Title of Change:	Change marking design and bonding method for WDFN6 devices
Proposed first ship date:	20 June 2017 or earlier after customer approval
Contact information:	Contact your local ON Semiconductor Sales Office or <Mutsuki.Niki@onsemi.com>
Samples:	Contact your local ON Semiconductor Sales Office
Additional Reliability Data:	Contact your local ON Semiconductor Sales Office or <Satoru.Fujinuma@onsemi.com>.
Type of notification:	This is a Final Product/Process Change Notification (FPCN) sent to customers. FPCNs are issued 90 days prior to implementation of the change. ON Semiconductor will consider this change accepted, unless an inquiry is made in writing within 30 days of delivery of this notice. To do so, contact <PCN.Support@onsemi.com>.
Change Part Identification:	Affected products will be identified with date code.
Change category:	<input type="checkbox"/> Wafer Fab Change <input checked="" type="checkbox"/> Assembly Change <input type="checkbox"/> Test Change <input type="checkbox"/> Other _____

This Process Change Notification is to notify customers of the following changes:

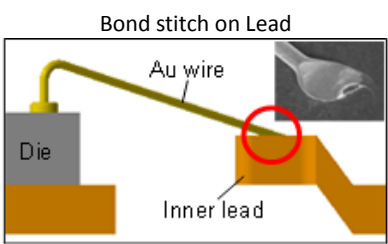
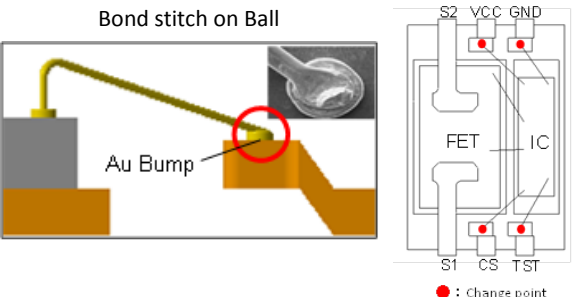
- Change marking design of WDFN6 to adopt the eject pin at mold release
- Change top mark from 3-liner to 2-liner
- Change WDFN device bonding method from bond stitch on lead to on ball (BSOB)

Before Change					After Change				
	Description					Description				
Package design	No eject pin					Adopt the eject pin				
Part number	5111C01	5111C02	5111C05	5112C01	5132C01	5111C01	5111C02	5111C05	5112C01	5132C01
Marking design	05111 C01MT AYWW .	05111 C02MT AYWW .	05111 C05MT AYWW .	05112 C01MT AYWW .	05132 C01MT AYWW .	C0501 AYWW .	C0502 AYWW .	C0505 AYWW .	CB201 AYWW .	CD201 AYWW .
bonding method
